Your ref: 999859517-10396
Our ref: 12644380

Response to Request for Further Information – Macraes Phase IV

GHD provides this letter in response to Otago Regional Council's request for further information letter under Section 92(1) of the Resource Management Act for consent application number RM.24.184 (Dated 09 December 2024).

**Groundwater Bores in Relation to
Modelled Sulphate Plume**

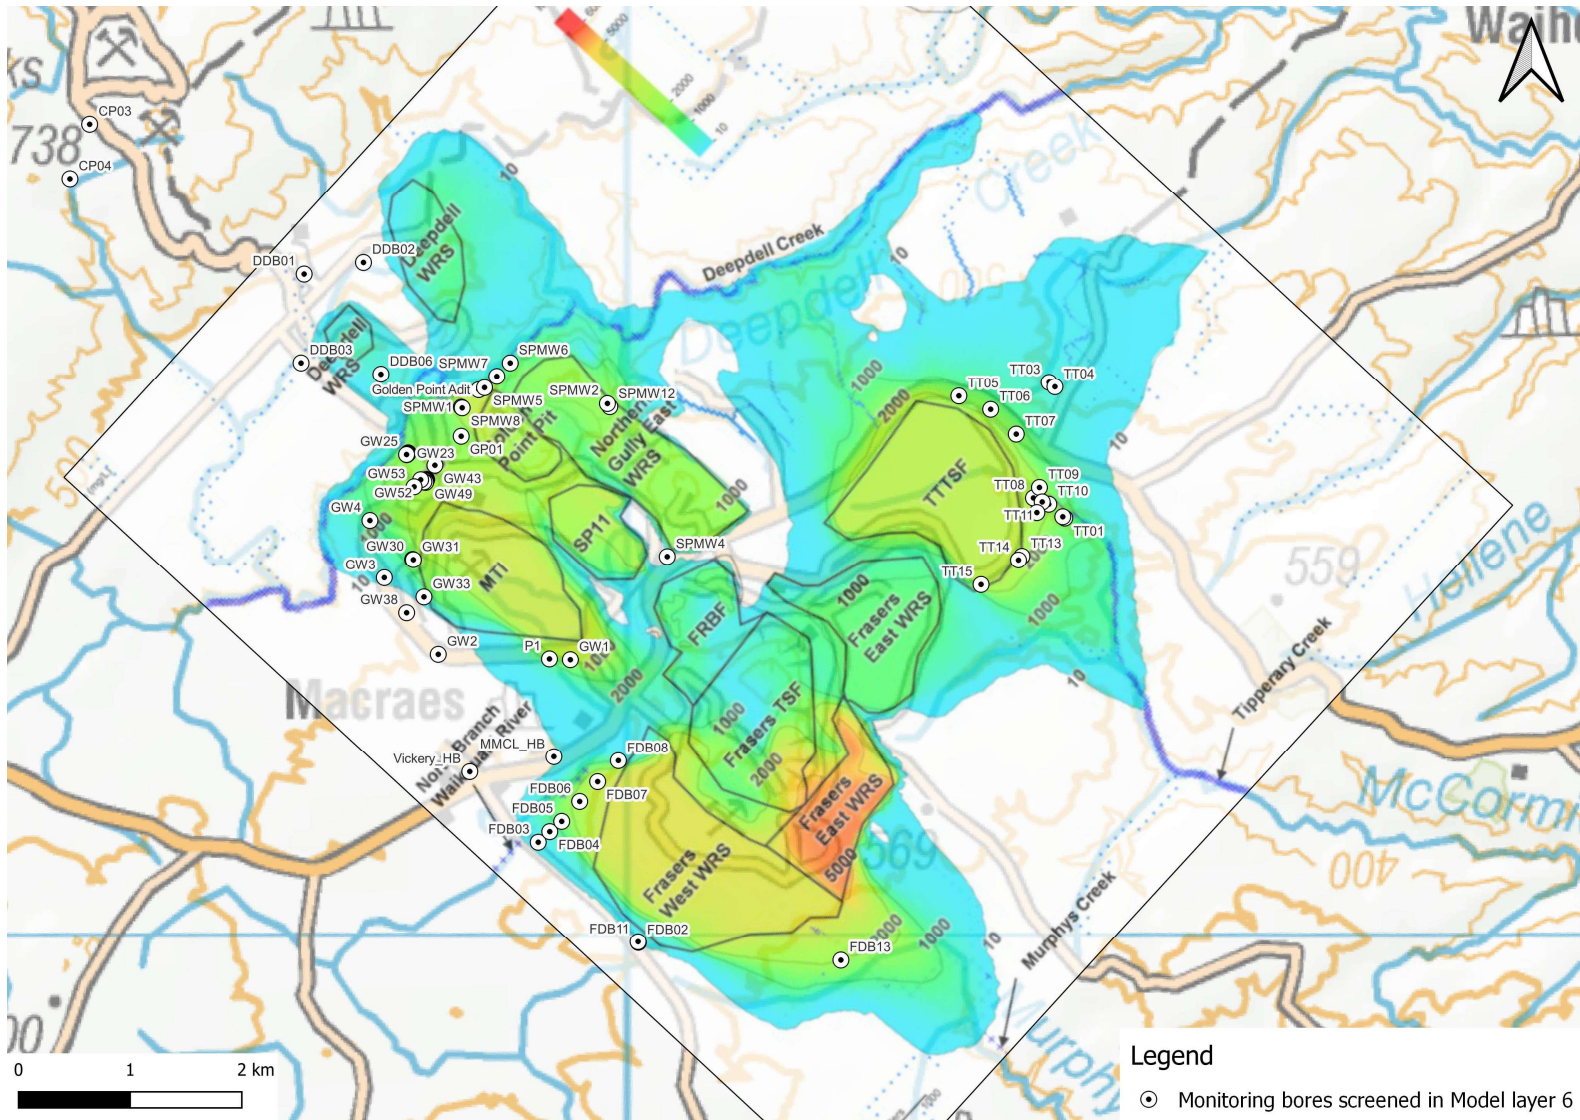
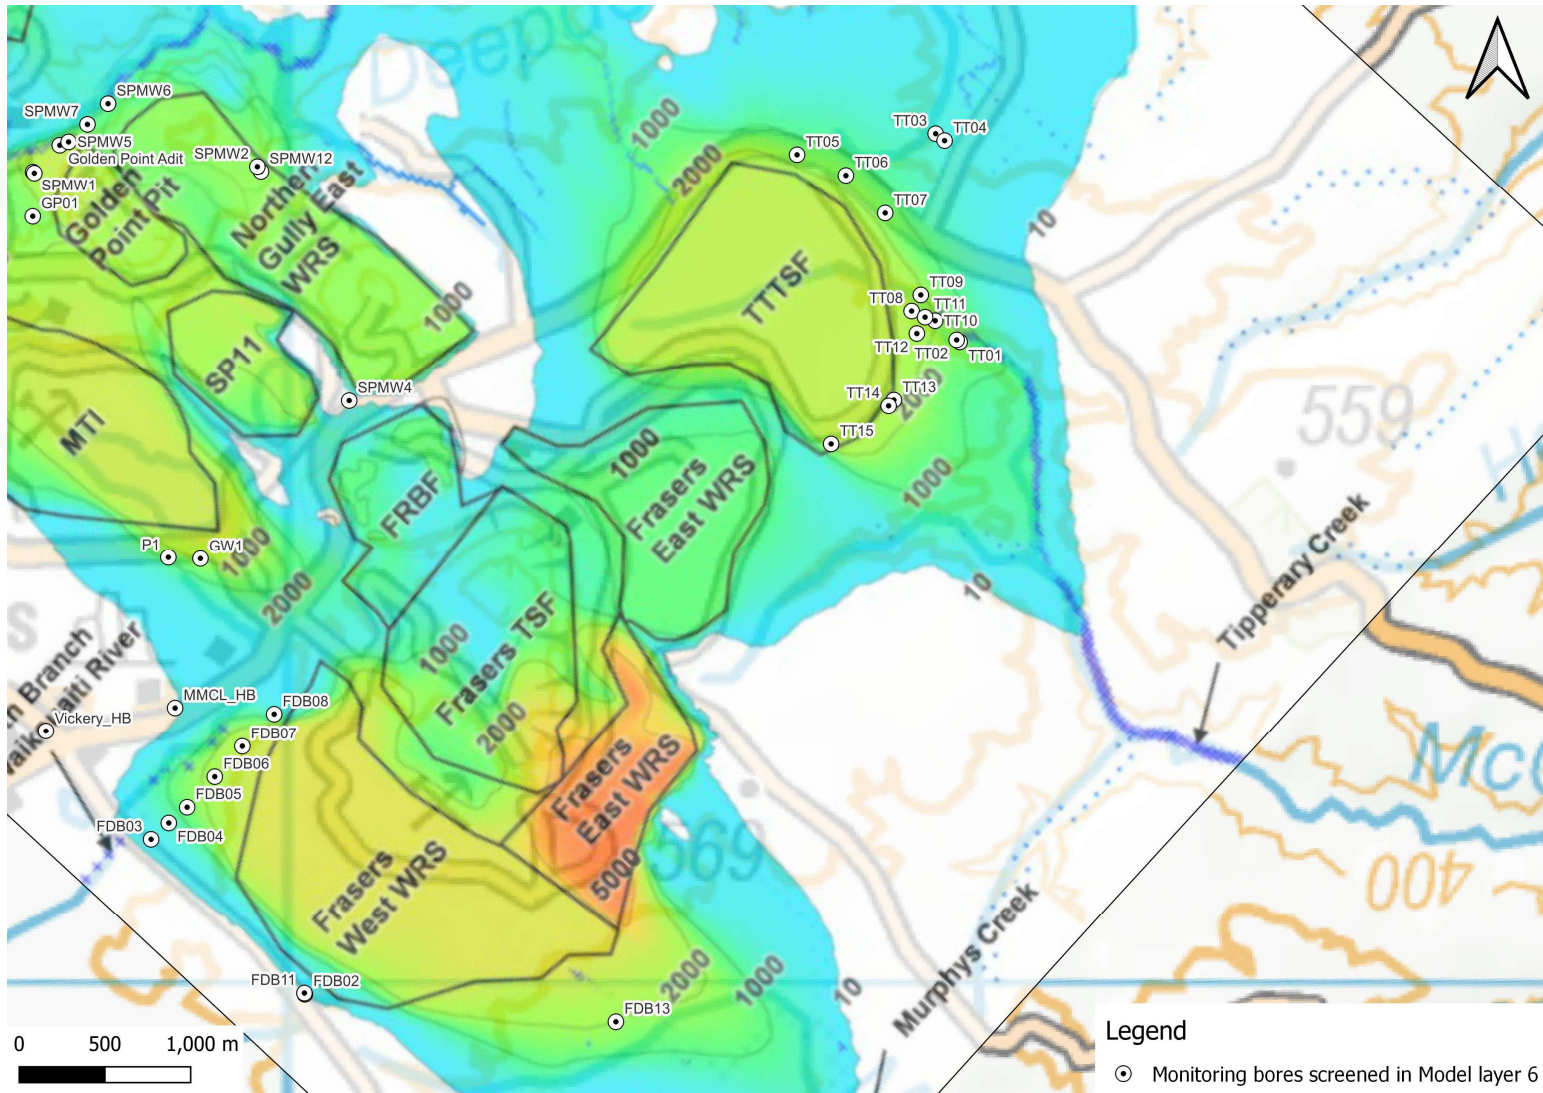
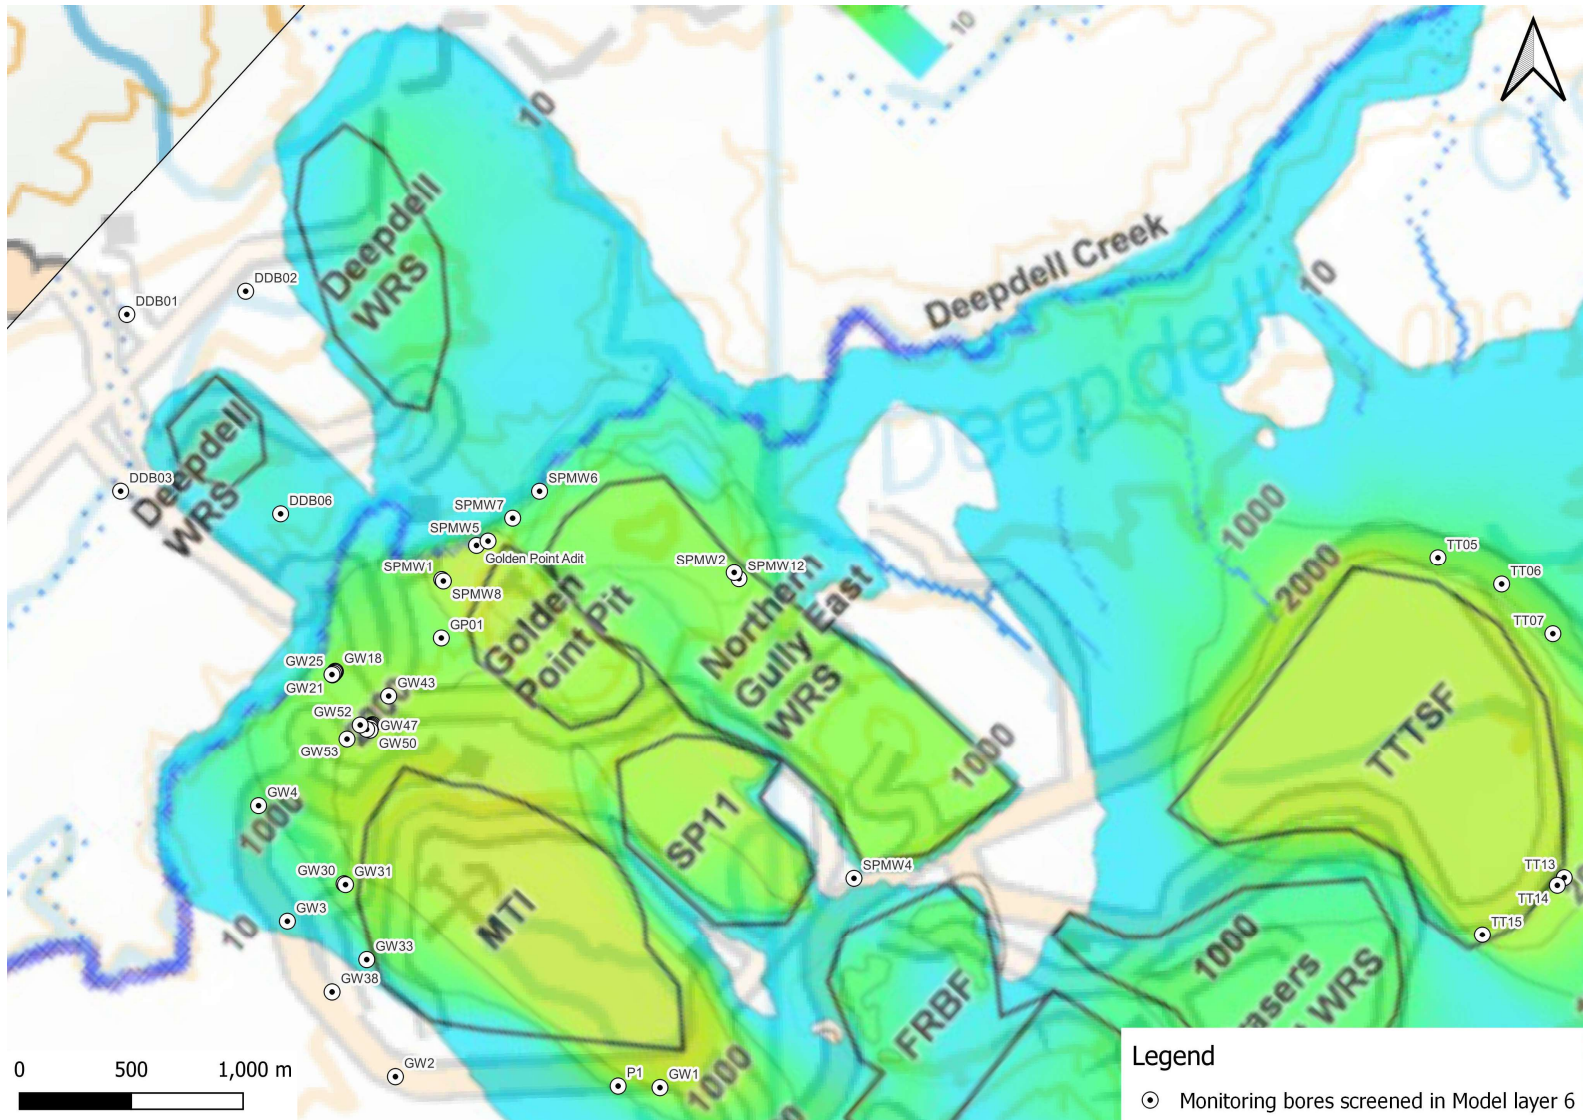
<p>- Continuous flow monitoring within the North Branch Waikouaiti River (NBWR), Deepdell Creek and Mare Burn below the mine site.</p> <p>- Continuous electrical conductivity monitoring in the North Branch Waikouaiti River, Deepdell Creek and Mare Burn catchments to better understand the current range and distribution of water quality parameters within these surface water bodies and catchments.</p> <p>- A control site for background water quality monitoring within the NBWR be investigated.</p> <p>It is recommended that these measures should be implemented as soon as practicable.</p>
<p>4.10</p>	<p>It is difficult to have any certainty that the available groundwater data is representative as the catchments are not presented for all of the locations relative to monitoring bores and activities, and the screen elevations are not documented within any of the assessments. How representative is water quality data available for the model in terms of existing groundwater within each catchment? Can a conceptual model or GIS layers be provided that presents the available monitoring locations and screen elevations relative to activity elevations and catchments?</p>

<p>The screen information for groundwater monitoring wells (where known and where assumed) are provided in Appendix B with screen depths varying between shallow (surface) to deep (ca. 100 m) at various locations throughout and surrounding the site. The locations of these monitoring wells screened in the moderately weathered schist (layer 6 of the model – in which the maximum modelled extent of the groundwater sulphate plume is located) are depicted in Appendix C. Layer 6 incorporates the upper weathered schist layer, is approximately 50 metres thick and is present immediately below modelled layers 1-5 (which represent the top 1-10 m below the in-situ surface and mine impacted materials). The monitoring wells and screen intervals are positioned to intersect:</p> <ul style="list-style-type: none"> – likely seepage pathways down gradient of site features, – adjacent receiving surface waters where groundwater could discharge to nearby surface waters – and/or are located surrounding the site to understand contaminant mobilisation both vertically and laterally within the groundwater system. <p>The current bores and screen installations are considered suitably located and they cover varying groundwater depths down hydraulic gradient of most site structures where significant contaminant sources and potential mobilisation pathways are present and/or are anticipated.</p> <p>The existing groundwater monitoring wells are grouped generally into the following area/categories:</p> <p>Deepdell</p> <p>A series of monitoring wells (DDB01 -DDB06) either side of Deepdell Creek are installed between 17 m to 58 m below ground surface. No screen information on these monitoring wells is available, however it is assumed (based on the screen levels of the other monitoring wells) that they are screened at the base. These monitoring wells detect groundwater seepage from the Golden Point / Round Hill / MTI / SP11 area to the south and the Deepdell North and South mining areas to the North prior to discharge to Deepdell Creek.</p> <p>Furthermore, a cluster of monitoring wells are located down hydraulic gradient of the MTI and intersect groundwater in the inferred seepage pathway between ca. 7 and 17 m deep (GW18, GW19, GW20 and GW21) and 18 and 26 m deep (GW22, GW23, GW24 and GW25).</p> <p>North Branch Waikouaiti</p> <p>A series of monitoring wells (FDB01-FDB10) are located between the rim of Frasers Pit and the upper headwaters of the North Branch Waikouaiti River. These wells are screened between surface and 10 metres below ground level and intersect seepage pathways draining to the receiving surface water environment with the aim of detecting contaminant mobilisation from the Frasers Pit and backfill area.</p> <p>TTTSF</p> <p>Groundwater monitoring wells TT01 – TT15 are installed at the base of the TTTSF within the underlying bedrock at depths of between 12 to 25 metres below the surface. It is our understanding that they are installed with a 6m screen from the base. These monitoring wells intersect groundwater seepage from the TTTSF within the Tipperary Creek and Cranky Jim's Creek catchment areas.</p> <p>In addition to the above, selected groundwater monitoring wells are present at other locations throughout the site that are screened to intersect groundwater at varying levels within the groundwater table.</p>
